# Review of PJM Mark To Auction FTR Designs

PJM Markets & Reliability Committee

December 6, 2018

Option H Future Year FTR Collateral

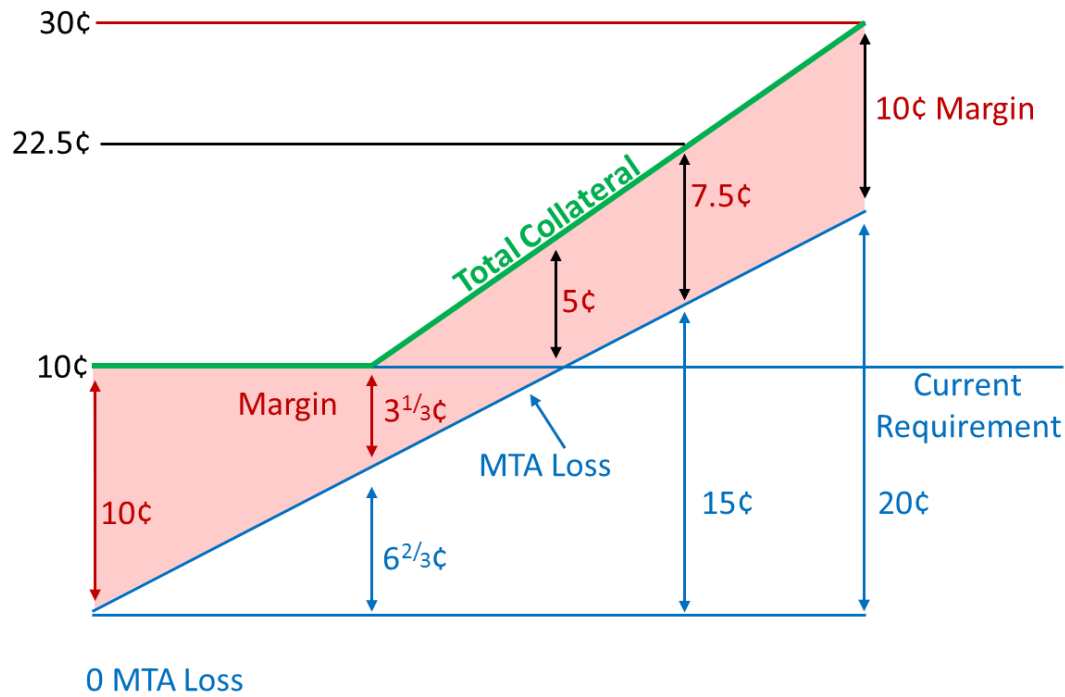
Under option H the collateral margin on future year FTR payments due would decline with decline in mark to auction value until the collateral margin was 1/3 of the current collateral margin. The margin would then rise with further declines in market to auction value.

The option H design in which the collateral margin first declines with declines in FTR value, then rises with additional declines in FTR value cannot be reconciled with any plausible theory of potential future changes in individual FTR value.

Option H Current Year FTR Collateral

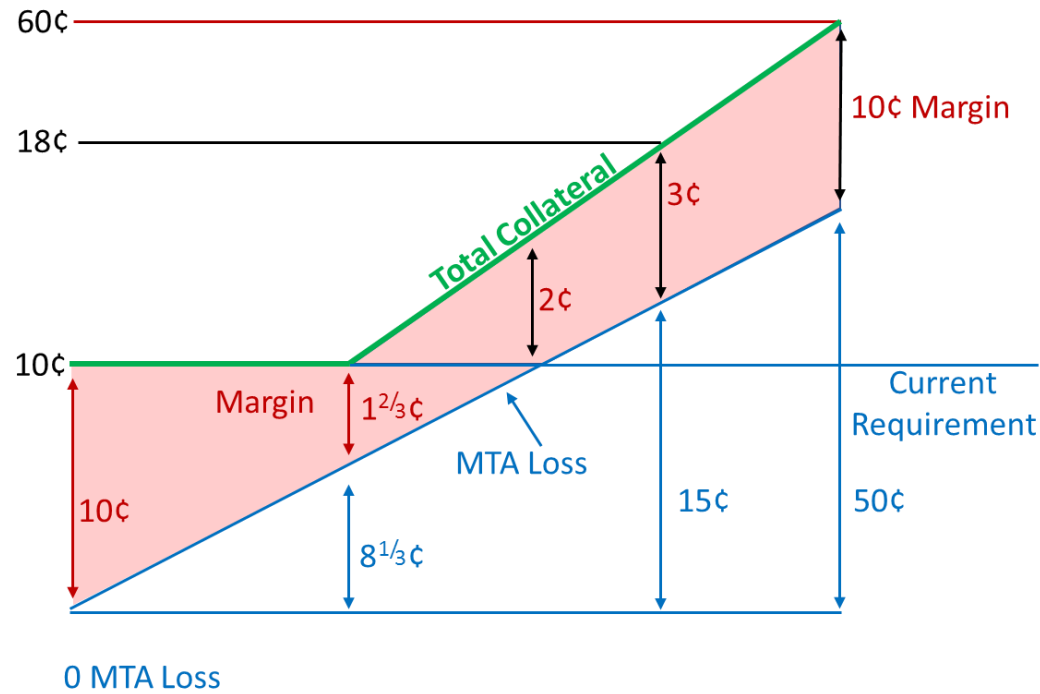
Under option H the collateral margin on current year FTRs would decline with decline in mark to auction value until the collateral margin was 1/6 of the current collateral margin. The margin would then rise with further declines in market to auction value.
